## Certificate of Appropriateness Case Report

*Filing Date:* February 5, 2013  
*Case No.:* **2013.0126A**  
*Project Address:* **1164 Fulton Street**  
*Historic Landmark:* Alamo Square Landmark District  
*Zoning:* RH-3 (Residential, House, Three-Family)  
40-X Height and Bulk District  
*Block/Lot:* 0777/011  
*Applicant:* Patrick Perez, Architect  
5429 Telegraph Avenue  
Oakland, CA 94609  
*Staff Contact* Shelley Caltagirone - (415) 558-6625  
shelley.caltagirone@sfgov.org  
*Reviewed By* Tim Frye – (415) 575-6822  
tim.frye@sfgov.org

## Historic Preservation Commission

Close up of window details at east elevation

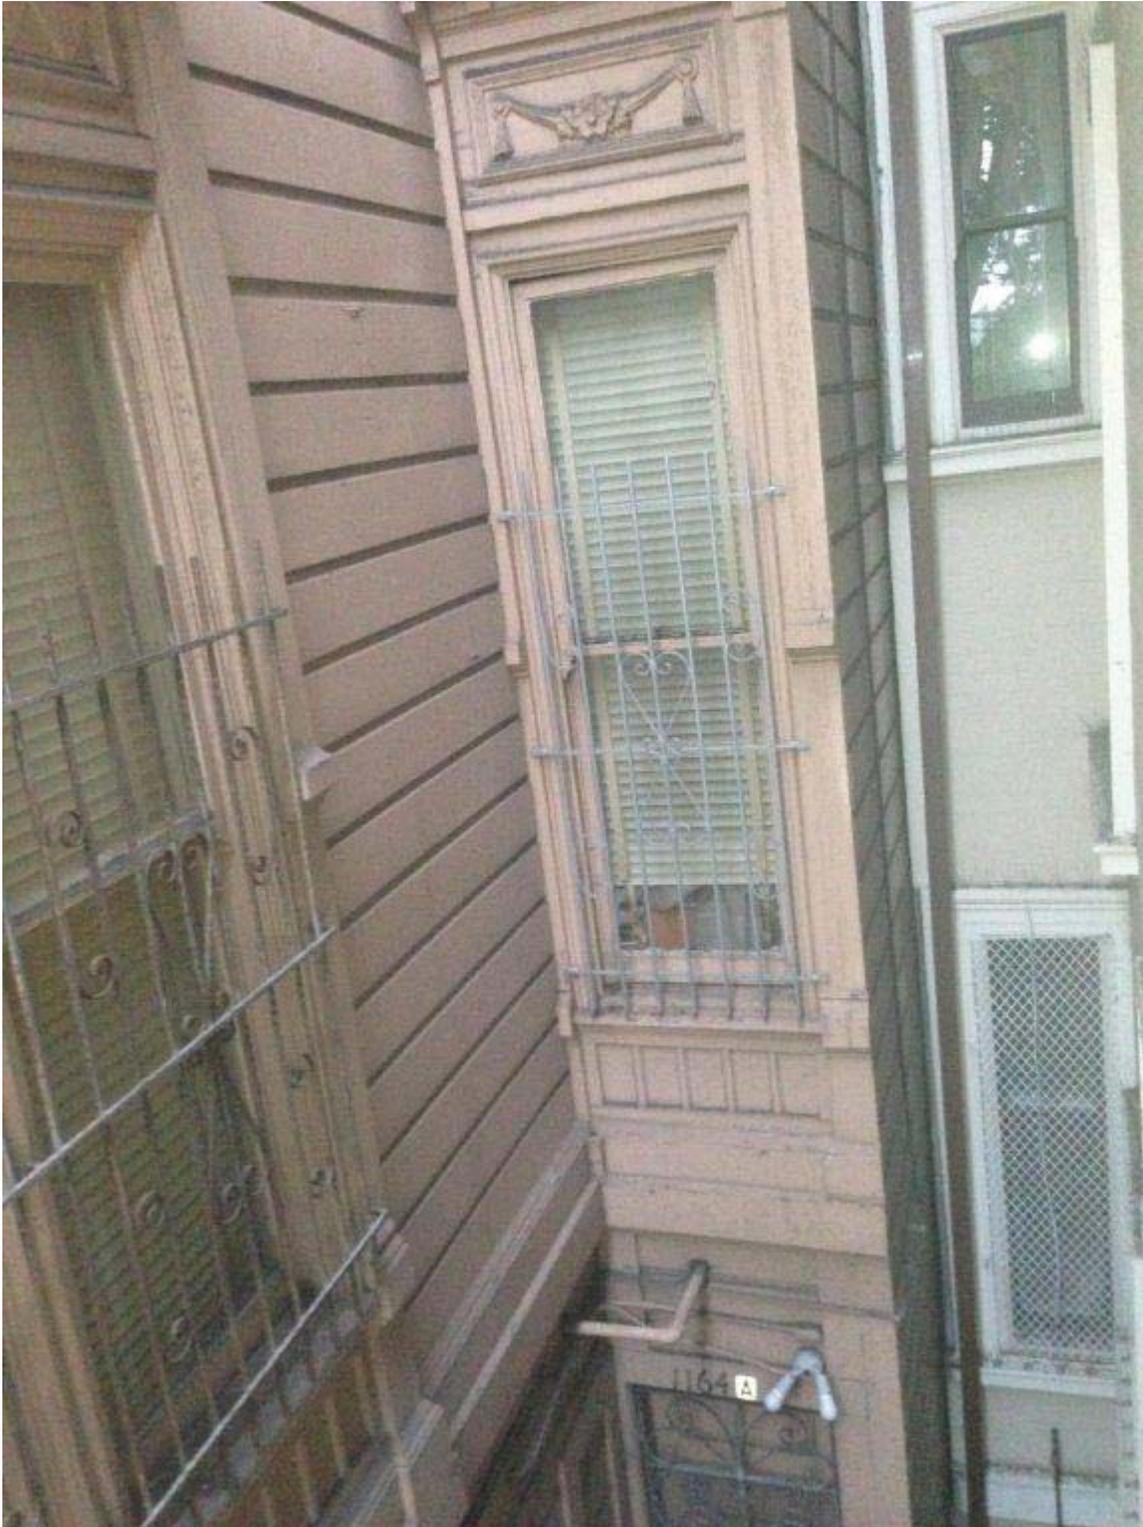
However, the project also proposes to modify two sets of paired windows at the visible secondary (east) façade, which are some of the few original features to have survived past alteration projects. While the overall integrity of the historic building would be improved by the proposed restorative work, this modification to the paired windows would diminish the integrity of original millwork and the fenestration pattern on this visible secondary facade. The work would also create a false sense of historical development by modifying the original paired windows without indicating where new material and dimensions have been introduced. If the building retained high historic integrity overall, the

work may not have a significant effect on the character of the building, but considering the building's history of alterations, staff recommends retention of these original features.

1. That the original paired windows on the secondary east façade be retained without modification.
2. That, as part of the Building Permit, the Project Sponsor shall submit additional information about the historic wood siding on the primary façade, including information on any scarring or shadow lines that denote removed trim and/or decorative details. Department Preservation staff shall conduct a site visit upon removal of the non-historic wood shingle siding. Upon removal of the siding and additional research, the Project Sponsor shall submit a revised façade elevation documenting to Department Preservation Staff for review and approval of the proposed window trim and details. New window trim and millwork shall be based upon documentary evidence from original wood siding, and shall accurately reflect the physical evidence, the subject property's original construction and the district's period of significance.
